Glasshouse Passive Pre-amplifier No.1

Wiring diagram
date: 20.05.04

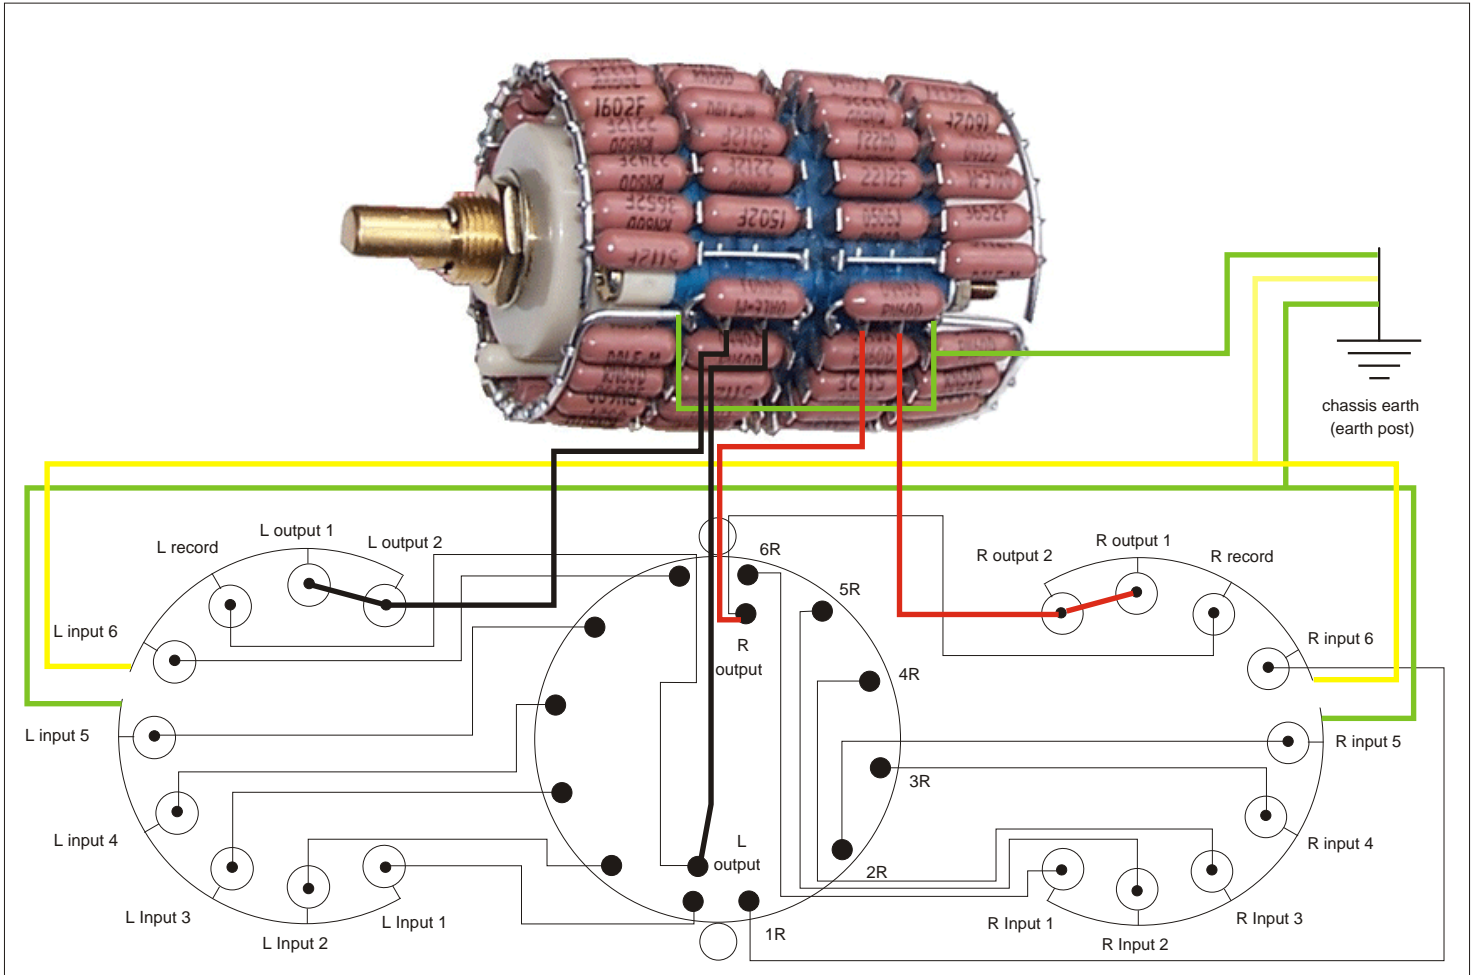
To achieve unity gain on position 23 it is necessary to make the following modifications to the Dale Vishay attenuator:

Denote a wire link that need to be soldered in (4 in total for this mod)
